ADDENDUM ONE

Area Cooperative Educational Services

ACES Education Center for the Arts

“ACES ECA Design/Build Monumental Stairs Renovation Project”

RFI #4:

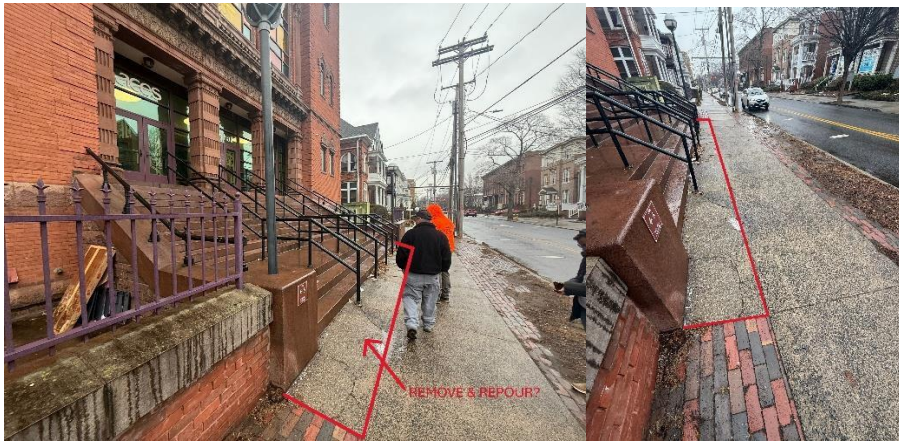
1. Corroded area: after power wash, caulk, repoint, and paint, does contract call for repainting the affected areas. [repoint and replace all brick and masonry. Only paint new surfaces](#)

RFI #7:

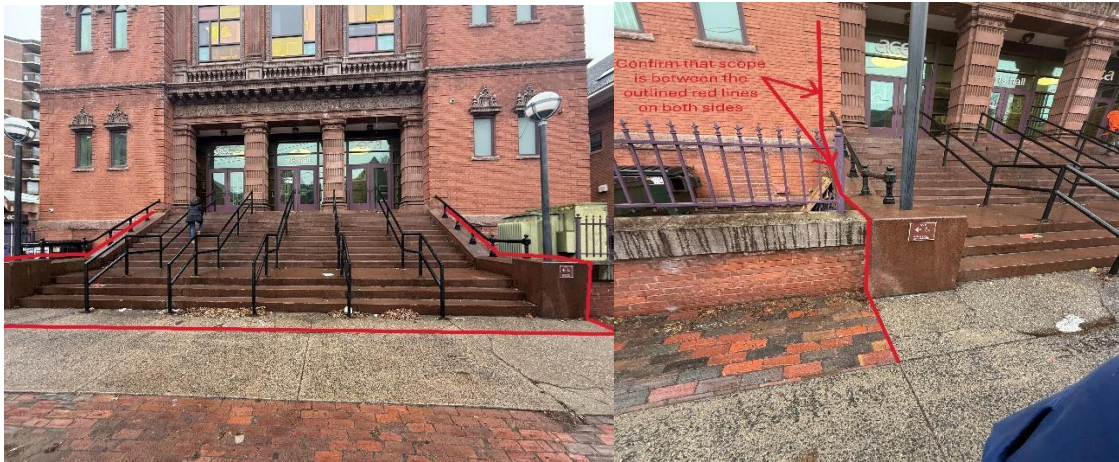
1. Confirm all railings need to be removed and brought back to the shop for sandblasting and finishing then reinstalled with engineered anchoring system. [Correct this part of the scope of work](#)
